CITY OF OBERLIN, OHIO

ORDINANCE NO. 26-51 AC CMS

AN ORDINANCE AUTHORIZING A SECOND AMENDMENT TO THE CONTRACT WITH ENVIRONMENTAL DESIGN GROUP, INC. OF AKRON, OHIO, TO PROVIDE FOR ADDITIONAL PROFESSIONAL ENGINEERING SERVICES FOR THE STATE ROUTE 58 SOUTH ACTIVE TRANSPORTATION IMPROVEMENTS TO GO INTO IMMEDIATE EFFECT

Subject: Professional Design & Engineering Services for State Route 58 South - Active Transportation Improvements Amendment #2
Environmental Design Group No. 22-00749-010

Figure 2

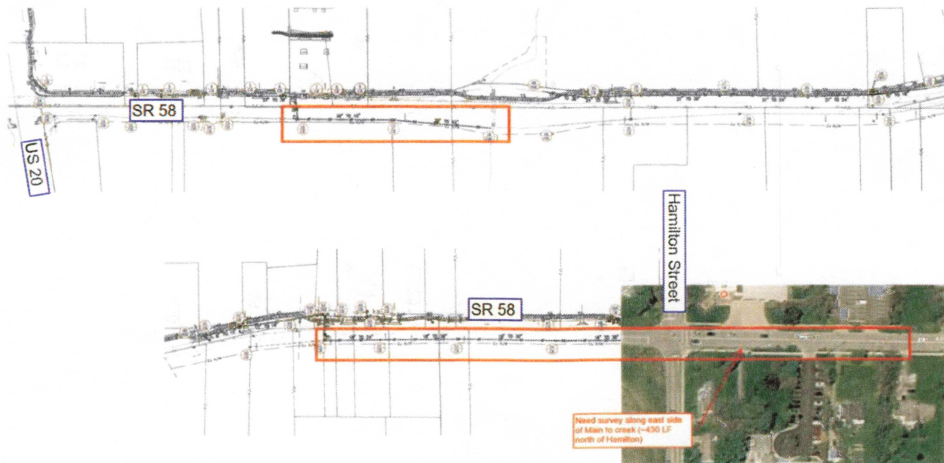
Topographic survey information will be obtained as shown in Figure 2 and outlined in red.

- Topography shall be obtained on the west side of the road where crossings will take place. It is anticipated that these crossings will take place at Hamilton, Reserve Way, Near Aldi's Entrance and US Route 20 (north side). This proposal assumes that topographic data will be gathered at a minimum of 50 ft north & south of the crossing areas.
